Product Change Notice (PCN)

PCN Number: PCN-0740976R-01

Product(s) Affected: *ACZ09 Series see part # listing below:*

Additional Information: *Depiction of base change:*

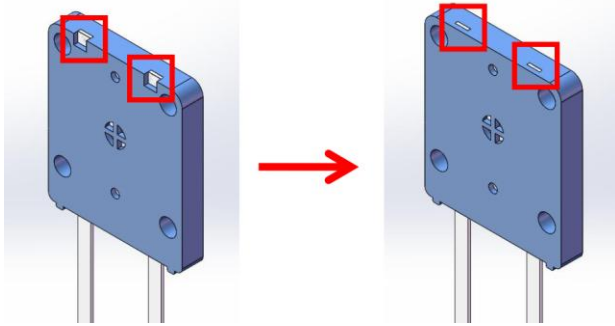
Reason(s) for Change: *Prevent connection between the switch base pins and the brackets.*

Description of Change: *Adjusted the pin cutout on the switch base*
